Contract Program: **Technical Support for the Reactor Systems Branch (L1697/P2)**

Subject of Document: **Review of Proposed Modifications to Emergency Procedure Guidelines for Anticipated Transients Without Scram Events**

Type of Document: **Technical Evaluation Report**

Date of Document: **November 1995**

Figure 9. Composite of ten different TRAC-BF1 ATWS calculations showing the maximum clad temperature of the low-power channel.

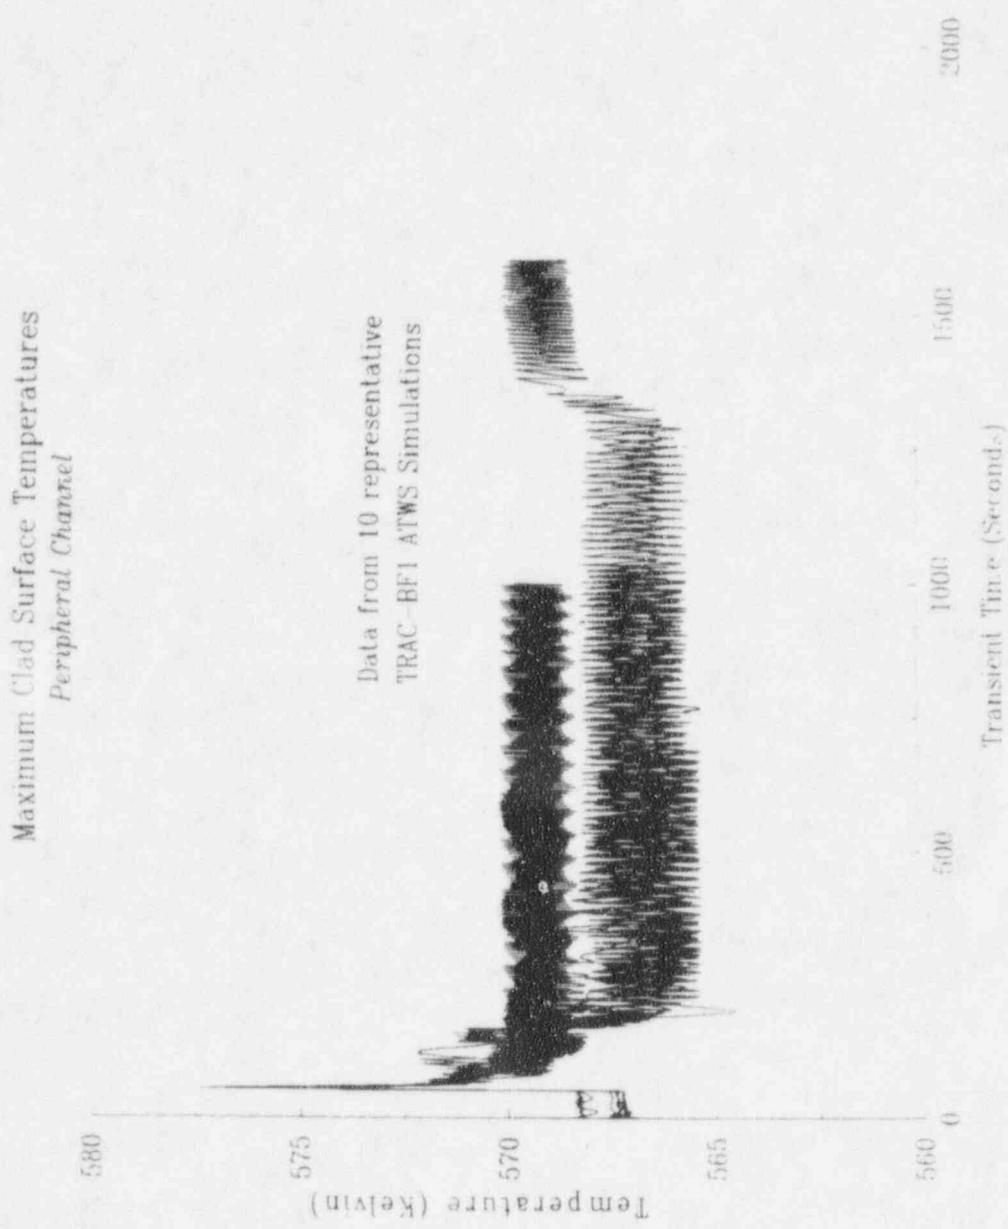
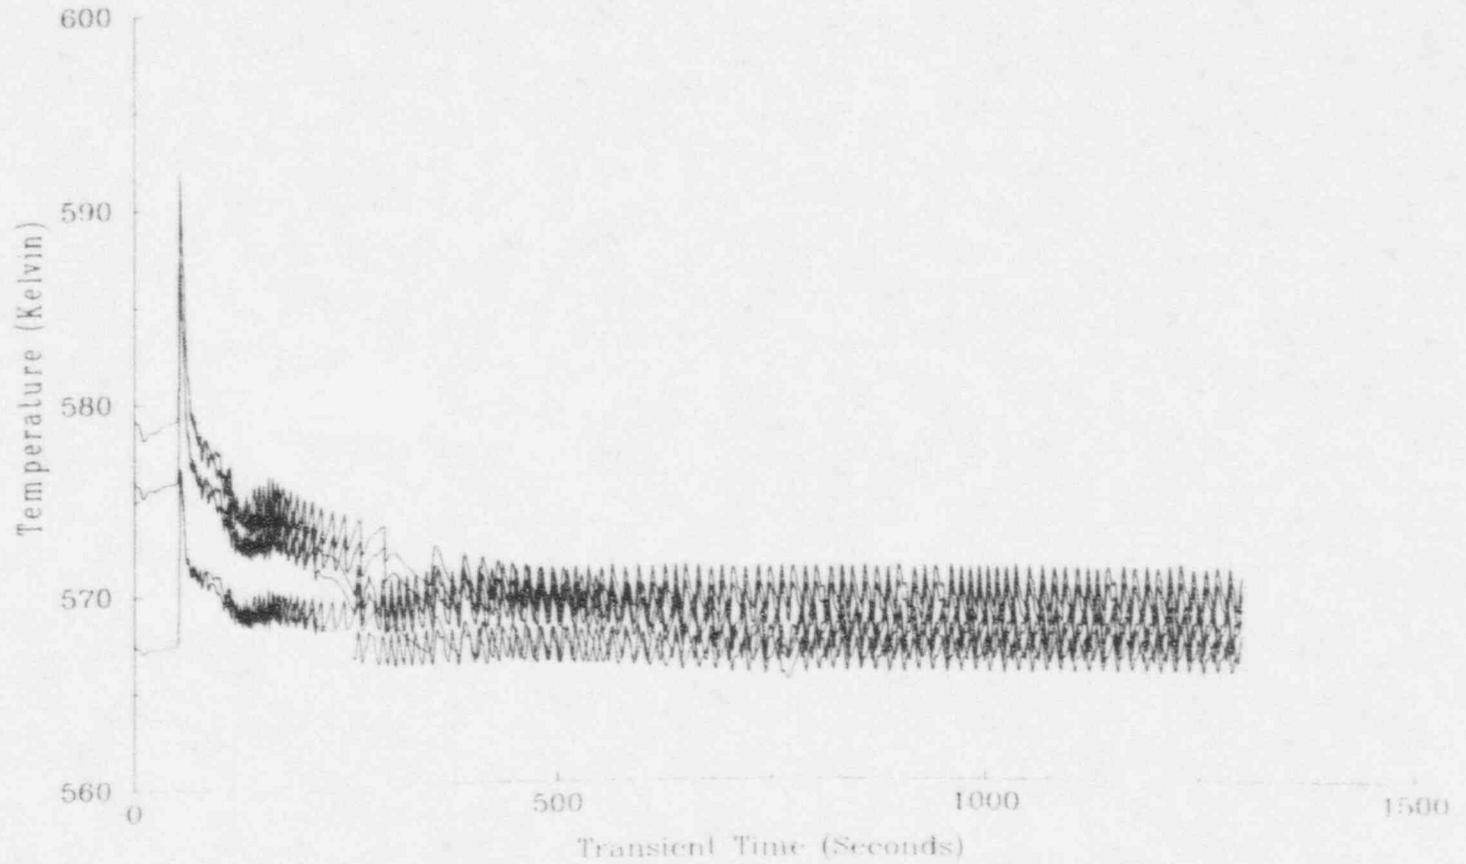
Figure 9 shows only the low-power peripheral channel for ten different TRAC-BF1 runs. Figure 10, in contrast, shows a composite of all the peak clad temperatures calculated by TRAC-BF1 for all channels in the two base runs: MSCWL and TAF + 5' level control with boron injection. This figure confirms that the peak clad temperature is within acceptable bounds, and it indicates that the two-phase level is well above the top of active fuel even when the collapsed water level is at the MSCWL.

Condensation-induced pressure fluctuations (concern (3) above) have been addressed in part by the TRAC-BF1 and RAMONA-4B calculations. Both of these codes have a mechanistic model for heat transfer between the subcooled liquid and steam phases; therefore, they compute the average equilibrium pressure that is reached in the node where steam condensation takes place. The result of these calculations exhibit pressure and power oscillations that are correlated with SRV cycling, but the magnitude of these oscillations is acceptable (see Figure 2), and it only results on peak clad temperature oscillations of the order of 5 °C, as seen in Figs 9 and 10.

Figure 12. Boron remixing time constant correlation from ref. 6

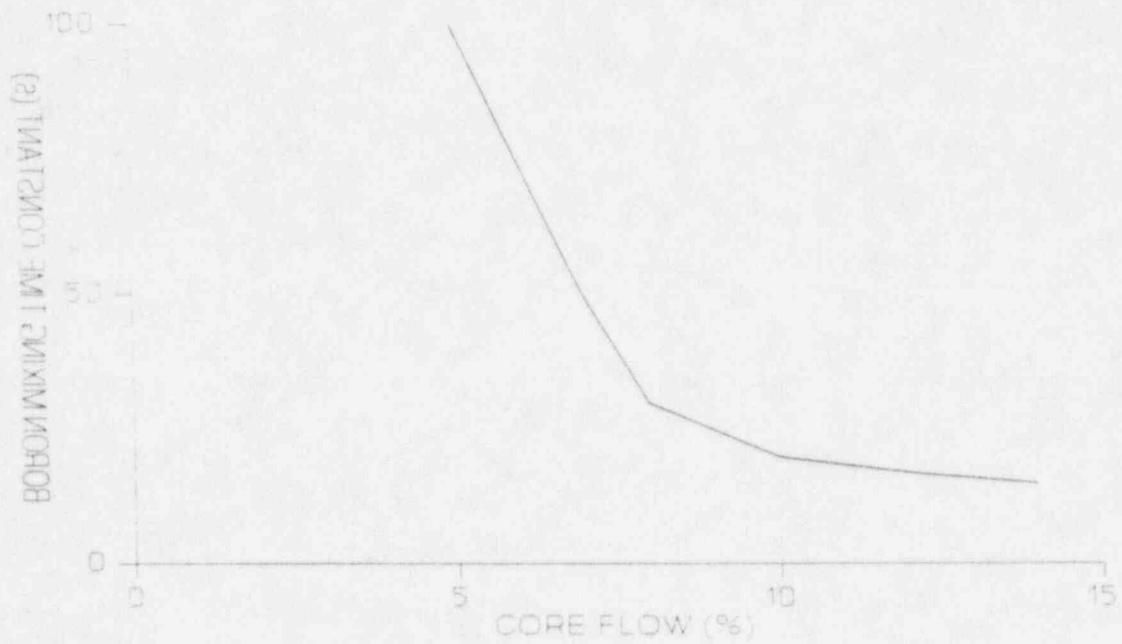
Successful ATWS management with all proposed strategies requires raising water level to remix the cold sodium pentaborate solution that precipitated to the bottom of the vessel when flow-stagnation conditions were reached. Figure 12 shows the remixing correlation determined from the 1/6 scale boron remixing experiments.¹⁰ The remixing efficiency is defined in terms of a "mixing time constant" (the time it takes to remix 50% of the stratified boron solution). From these experiments it was concluded that boron remixing would be essentially instantaneous (approximately 10 s) if more than ~10% recirculation flow is established once the level is raised.

Figure 13. Core thermal power following level increase assuming that boron does not remix.

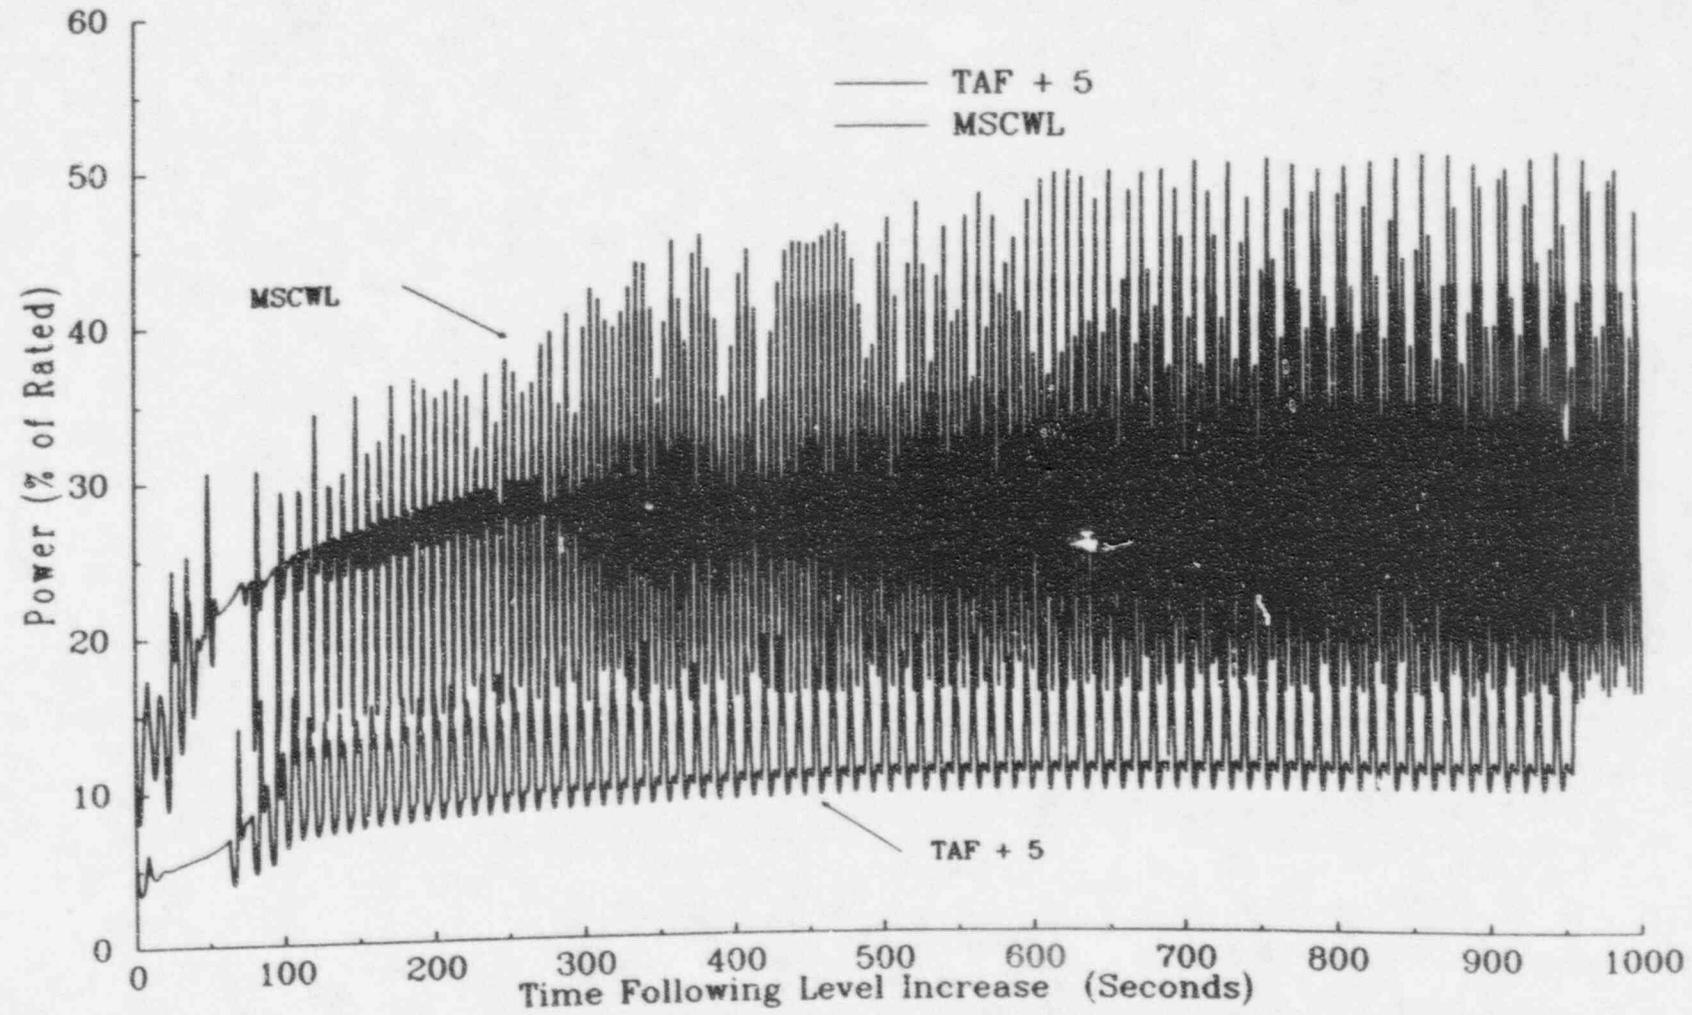
Figure 13 shows the core thermal power for the two level-control strategies if we assume that boron is not destratified when the level is raised. It can be observed from this figure that the power for the lower level strategy (MSCWL) is significantly higher than the power for the higher level strategy. This is due to the fact that the lower-level strategy has a smaller concentration of boron before the SLC injection begins to stratify; therefore, when the level is increased the flow increases and the power is higher than with the higher dissolved boron concentration of the higher-level strategy.

Figure 14. Recirculation flow following level increase assuming that boron does not remix.

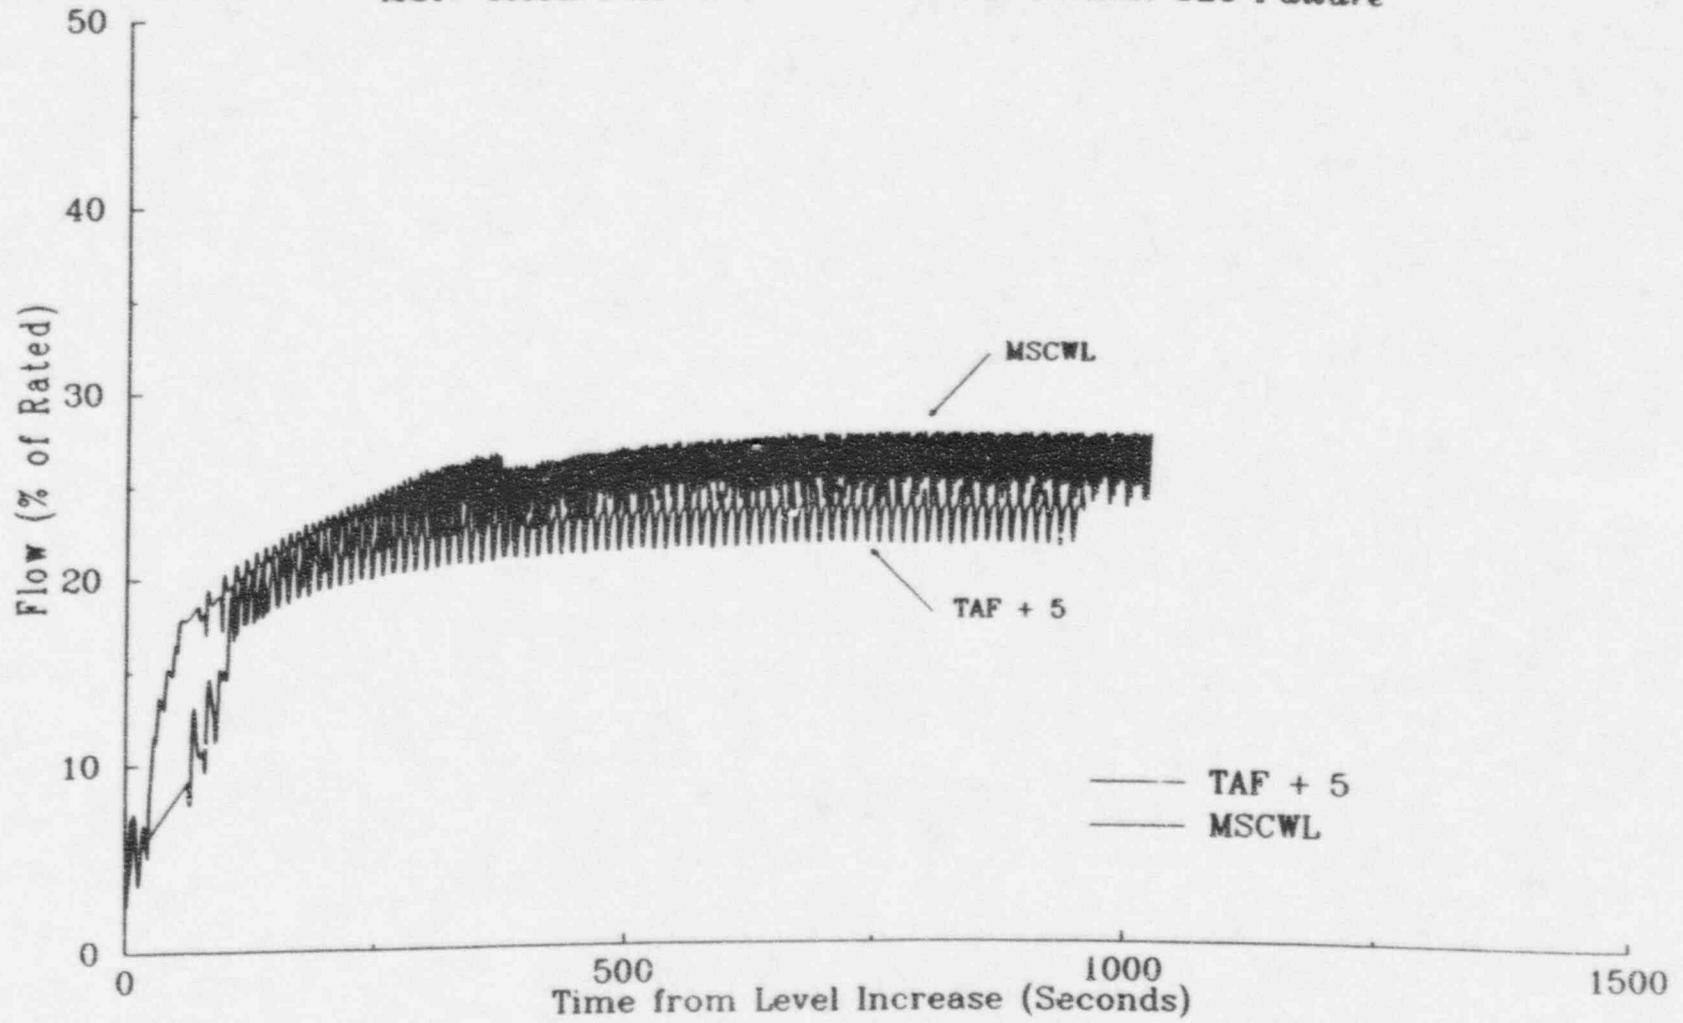
Figure 14 shows the flows reached after level increase (with failure to destratify) for both strategies. As it can be observed, both strategies reached approximately the same recirculation flow (greater than 20%) even though the power generation is quite different (see Fig. 13). This fact is not unusual and it indicates that the "natural circulation line" in the power to flow map is almost vertical, as expected. The calculations of Fig. 14 indicate that the reactor achieves a flow greater than 20% when the level is raised to remix the stratified boron; all available data indicates that stratified boron will remix at this high flow.
